PTS STANDARDS - 100 SERIES DRAWINGS
STANDARDS FOR ROADWAY CONSTRUCTION
APRIL 2022 EDITION – CHANGE NO. 2 – NOVEMBER 2023

PTS – 100 SERIES DRAWINGS

PENNSYLVANIA TURNPIKE COMMISSION
INDEX OF STANDARDS FOR ROADWAY CONSTRUCTION

FILE NAME: PTS-147.dwg
DRAWING TYPE: 5A
DATE: NOVEMBER 2023
SHEET 1 OF 1
PTS-147

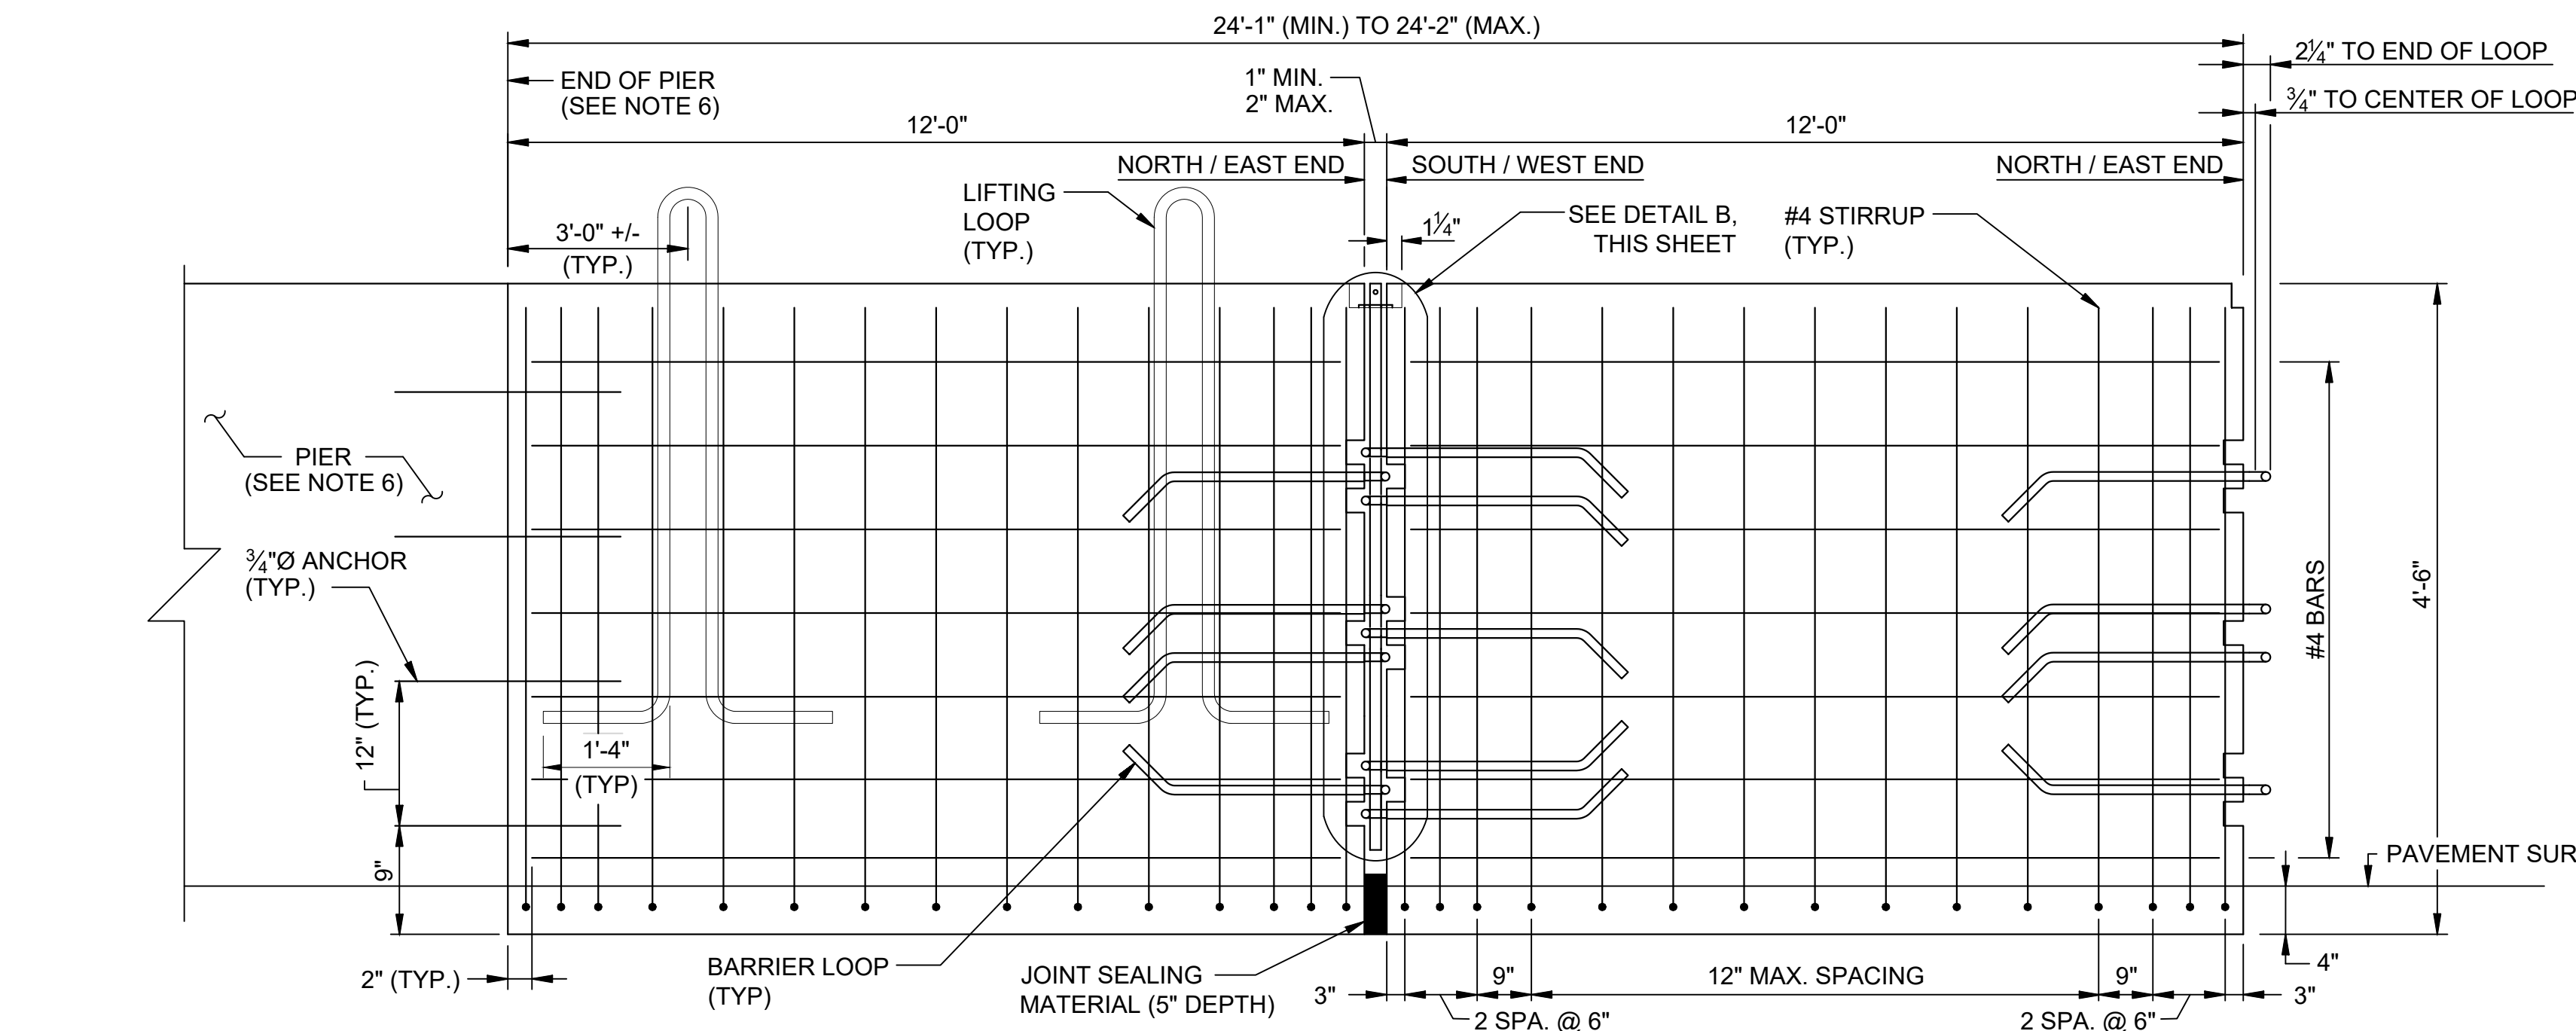
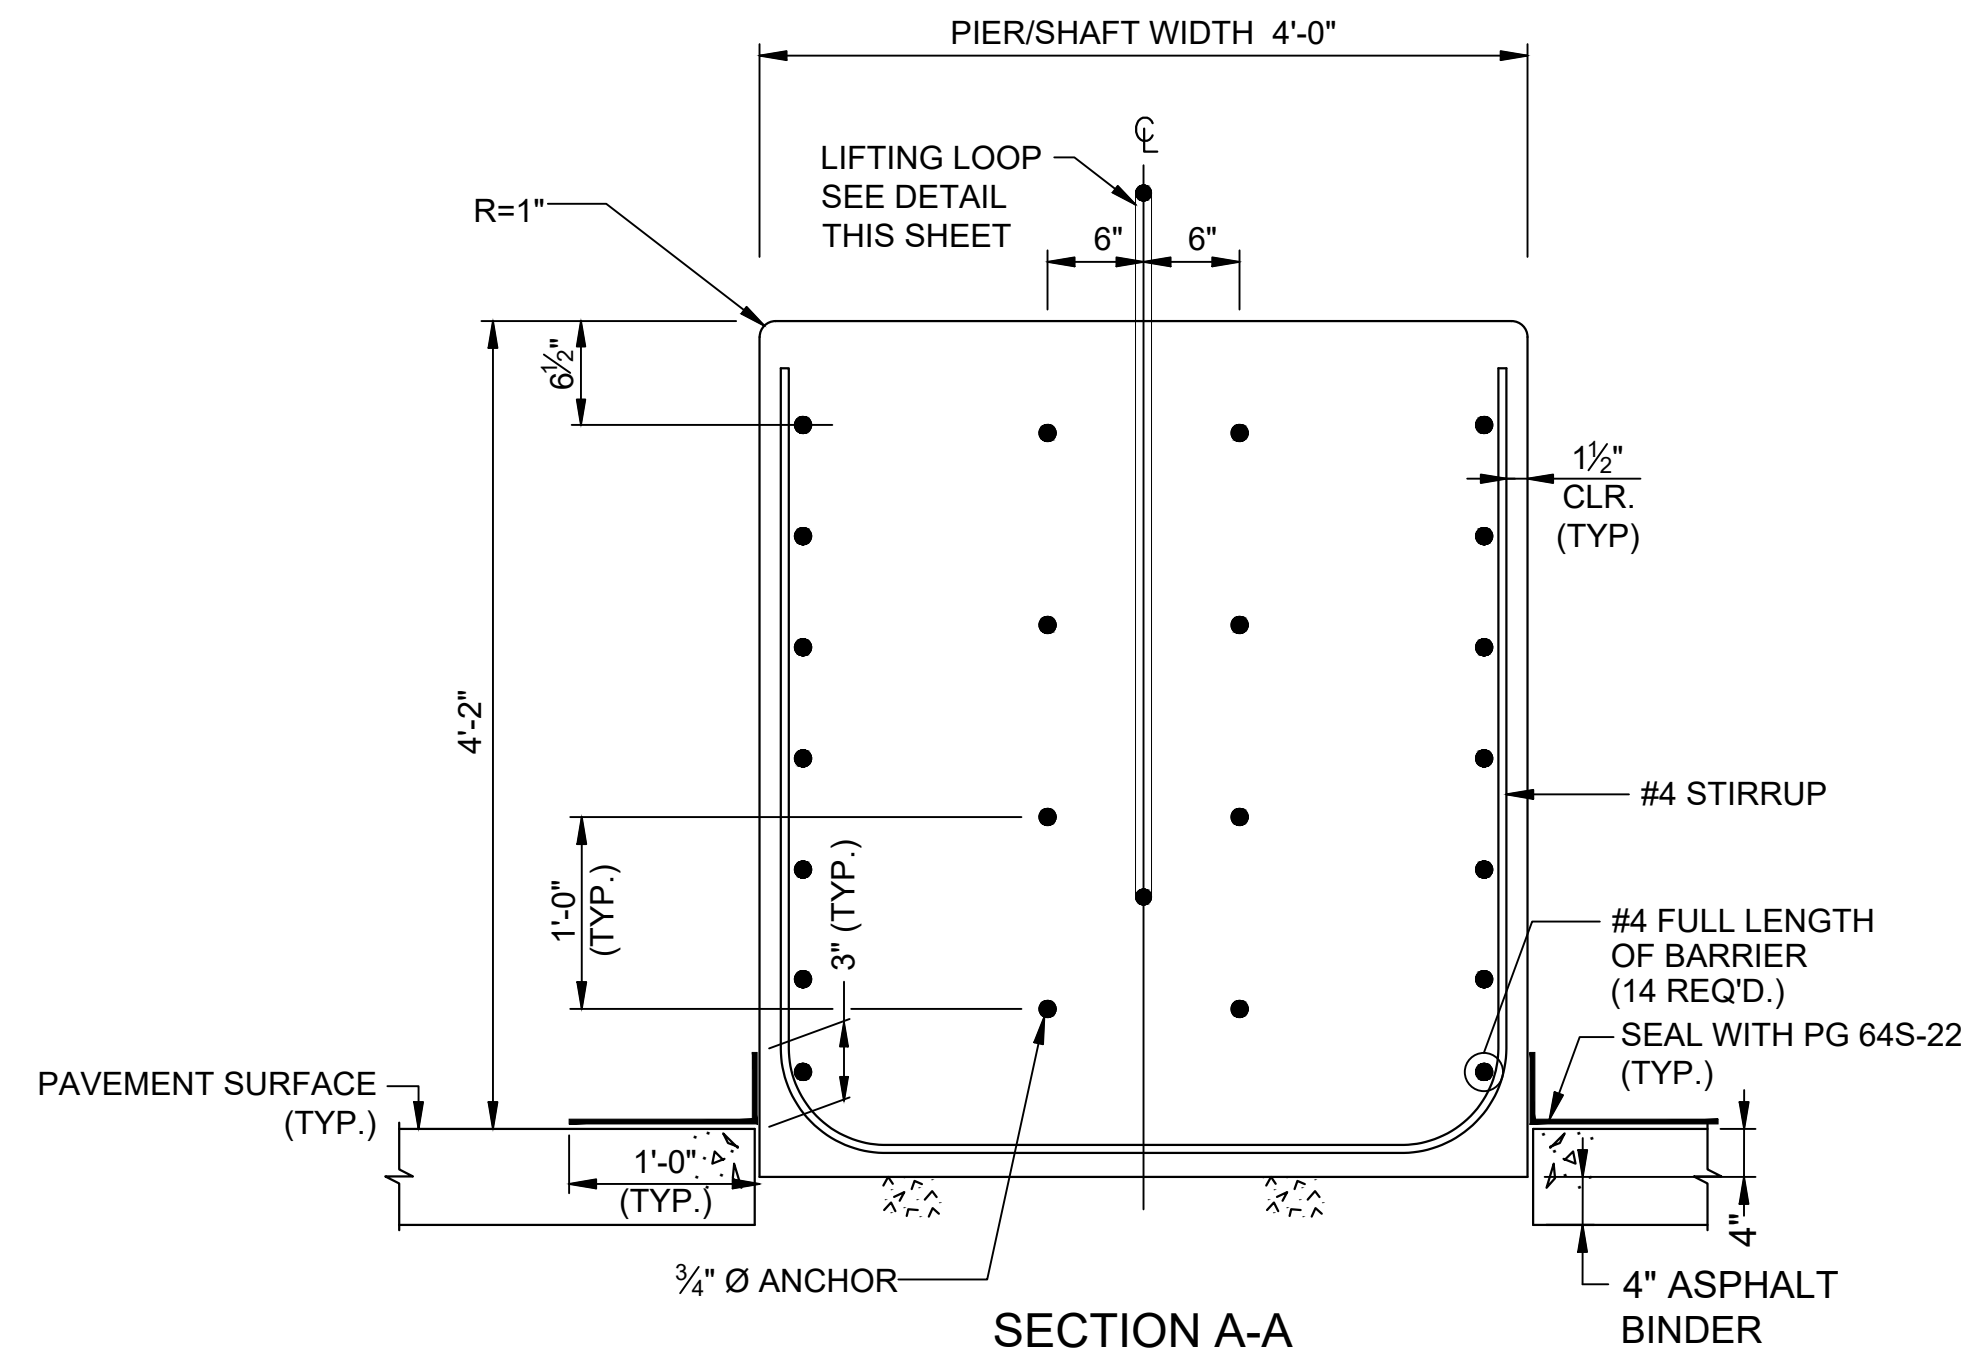
REVISED THE PLAN VIEW AND REPOSITIONED THE SECTION A-A LOCATION AND REVISED THE SECTION A-A WIDTH TO REFLECT THE NEW LOCATION.

REORDERED SHEET NOTES AND ADDED THE USE OF A PACHOMETER TO NOTE 12.

FILE NAME: PTS-148-2.dwg
DRAWING TYPE: 5A

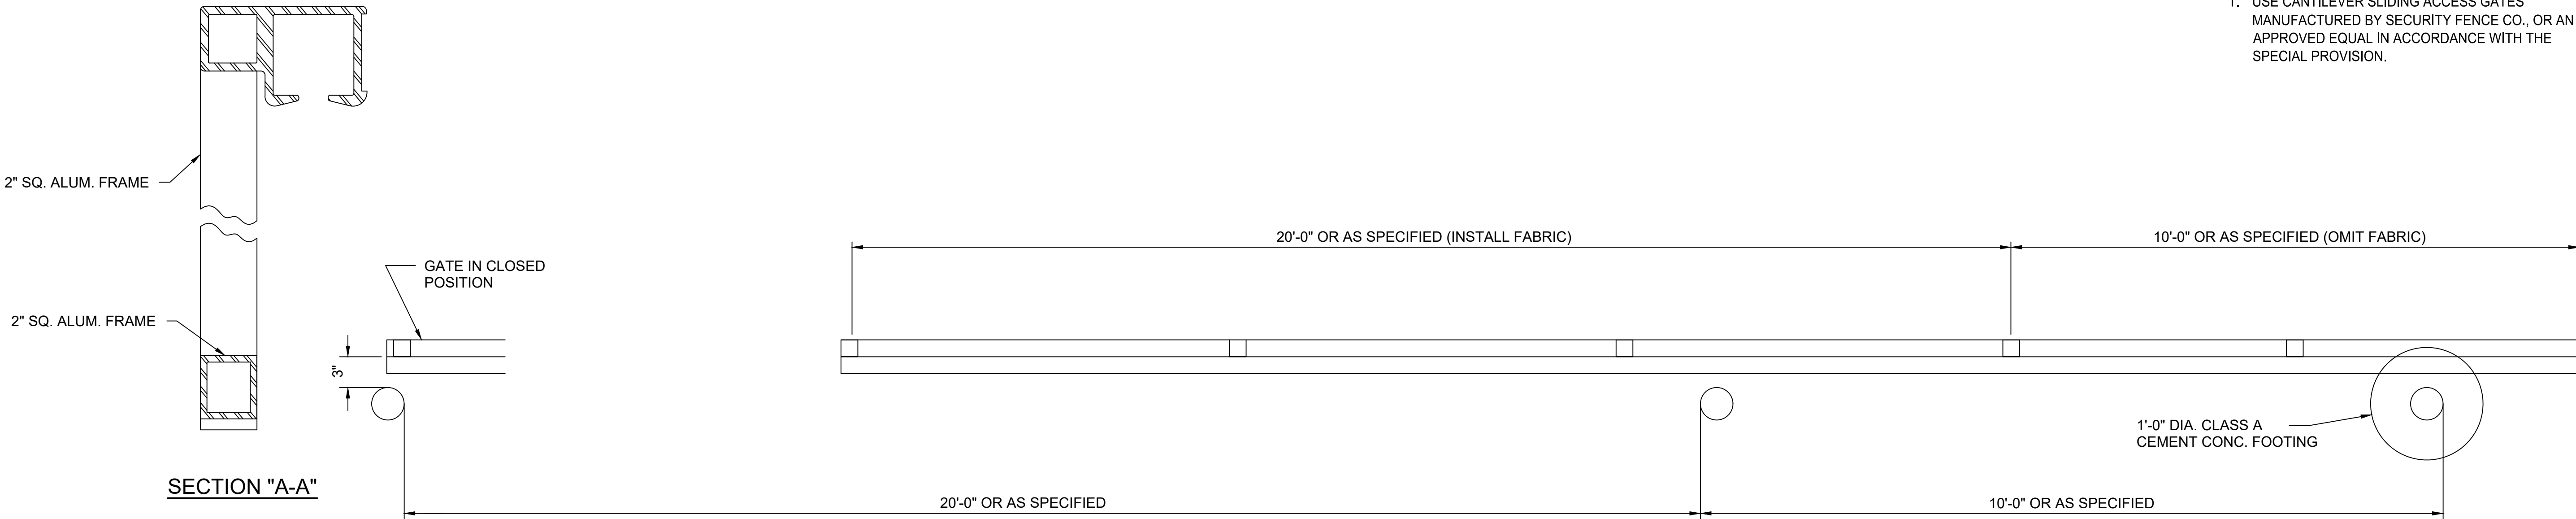
REVISED THE SECTION D-D WIDTH TO REFLECT THE NEW LOCATION.
